**CITY OF SAINT PAUL**  
**HERITAGE PRESERVATION COMMISSION STAFF REPORT**

**FILE NAME:** 172 East Fourth Street  
**DATE OF APPLICATION:** January 22, 2015  
**APPLICANT:** Twin Cities Public Television, JoAnn Hawkins  
**OWNER:** HRA, 25 Fourth Street West  
**DATE OF PRE-APPLICATION REVIEW:** February 12, 2014  
**HPC SITE/DISTRICT:** Lowertown Heritage Preservation District  
**CATEGORY:** New Construction  
**CLASSIFICATION:** Building Permit, Sign Permit  
**STAFF INVESTIGATION AND REPORT:** Amy Spong  
**DATE:** February 6, 2015

### **Skyway Atrium - Exterior Enhancements 2.0**

East 4th Street entrance

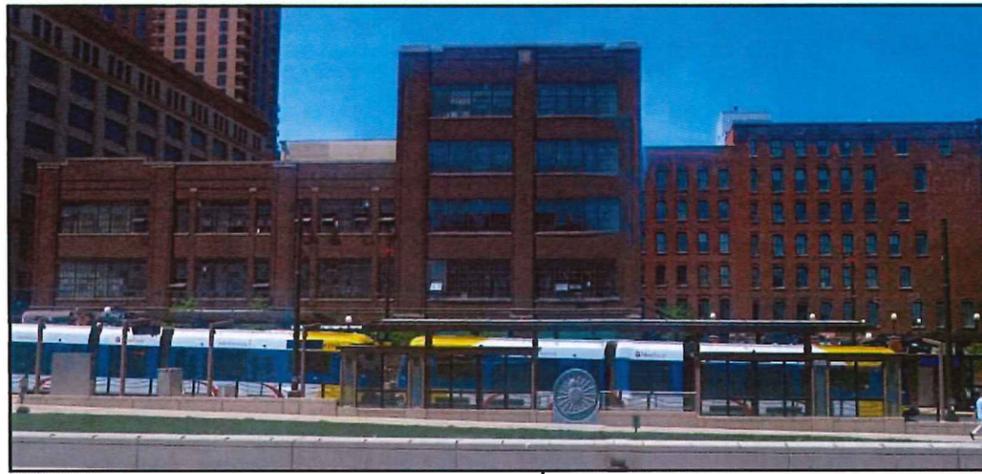
9. The guidelines state *“Signs should generally be lit from on the site. There should be no flashing, blinking, moving, or varying intensity lighting. Subdued lighting is preferred. Backlit fluorescent or exposed neon are generally inappropriate.”* The proposals for two internally illuminated signs (upper eastern wall and above the main 4<sup>th</sup> Street entrance) do not comply with the guidelines.

Sheet Title  
Exterior Elevations &  
Building Section

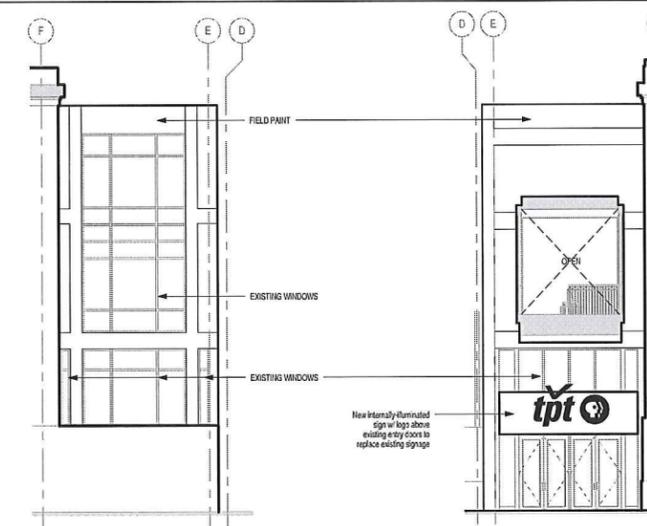
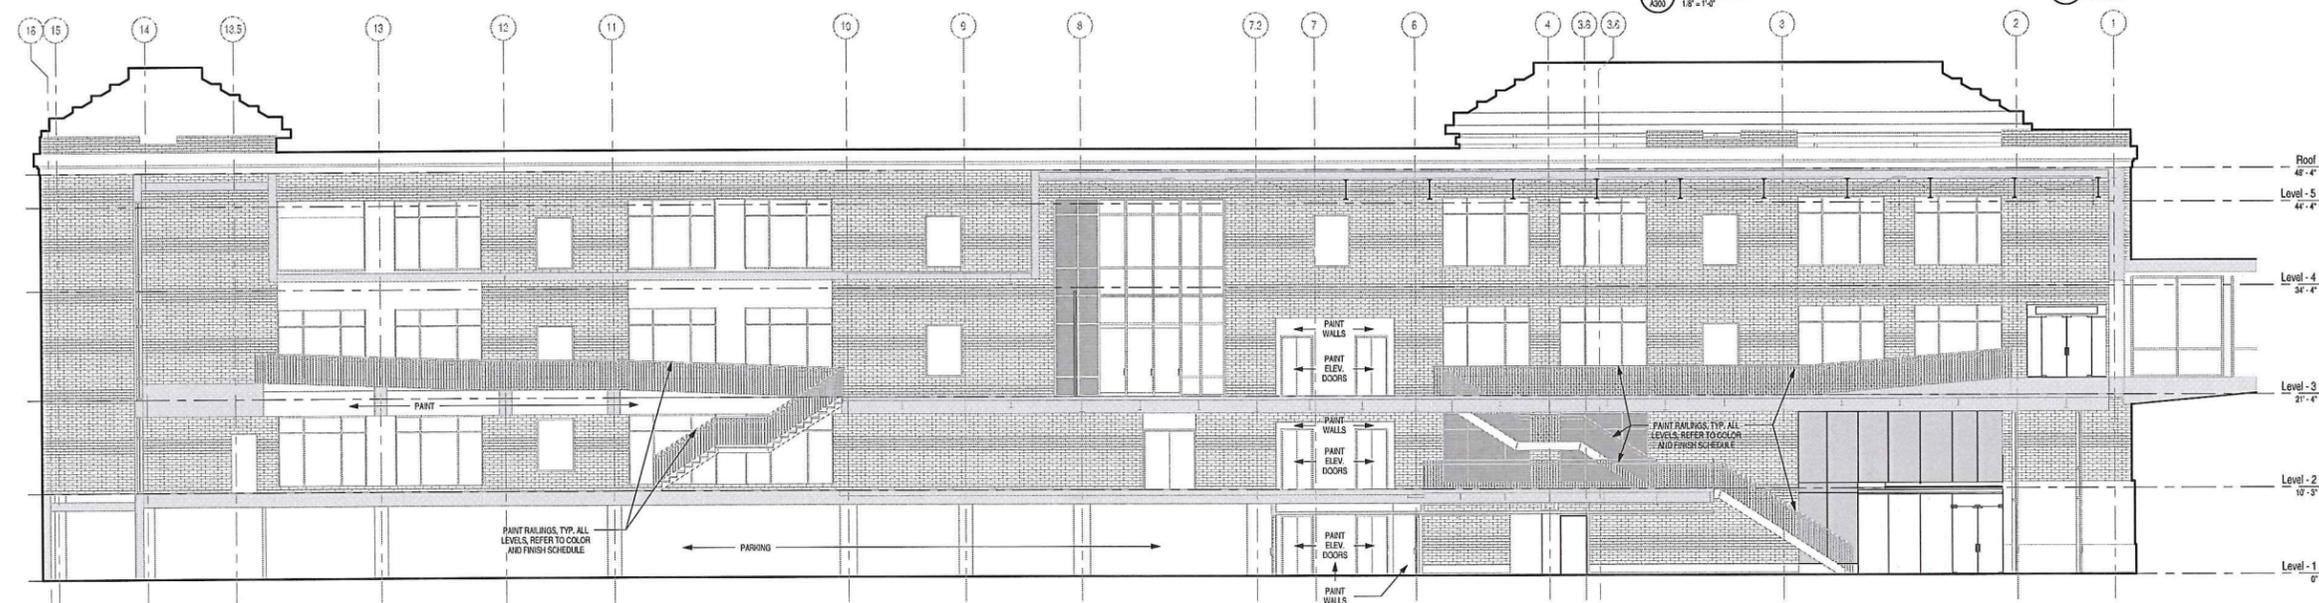
- 3. The Pre-Application states the eastern wall is of a substandard material with no relationship to the neighborhood or St. Paul Lowertown. The application does not make clear if the substandard nature is both visual and physical (structural) or just visually substandard. The proposal is not to replace the material but repaint it in an off-white color outside of the mural areas. The proposal to repaint the temporary material off-white and then consider it permanent does not comply with the former HPC findings and decision nor with the guidelines (unchanged when first applied in 1987 and 1989) that state *“Walls of buildings in the district are generally of brick, or occasionally of stone. All non-masonry surfaces, if painted, should be of colors compatible with the masonry character of the district.”* The off-

white is not compatible with the masonry character of the district and should be a darker color with a tone that is found in the variety of red, brown and yellowish tones of adjacent brick. The projection screen which requires the off-white color should be a temporary element in canvas that gets installed for events. More focus should be on making the temporary wall a more permanent and compatible feature within the Historic District, not making it further incompatible.

7. The guidelines state *“Double-hung windows are traditional in the district, and are preferred for new construction. Window mullions should emphasize their vertical direction.”* The applicant is proposing to improve the appearance of the “substandard” elevation by adding a new window within the existing opening on the skyway level. While not double-hungs as the guidelines recommend, they have a vertical orientation and relate to existing windows on the 4th Street elevation. However, the new window with mullions has proportions similar to a storefront and not a second story level window. The mullion and muntin pattern should be more consistent with second story warehouse windows that are adjacent and have similar sized openings.

8. Rhythm and Directional Emphasis. Rhythm can be found both in the relation of several buildings to each other, and in the relation of elements on a single building façade. The existing openings are not being altered to better comply with the guidelines, except for the new window on the main level east elevation. This will connect and open up the elevation more for the adjacent park but not connect to the street and sidewalk along 4<sup>th</sup> Street.

The location of the upper eastern wall does not comply with the guideline that states *“There should be no sign above the cornice line or uppermost portion of a facade wall.”* There is no historic fabric or architectural detailing being concealed. Given this is a highly visible secondary elevation, a painted sign that complements the character of the early painted signs may be acceptable in this upper wall location. The sign above the entrance on 4<sup>th</sup> Street does cover the transom windows but if there is a *“space separating them from the building”* this may be acceptable. More detail is needed.
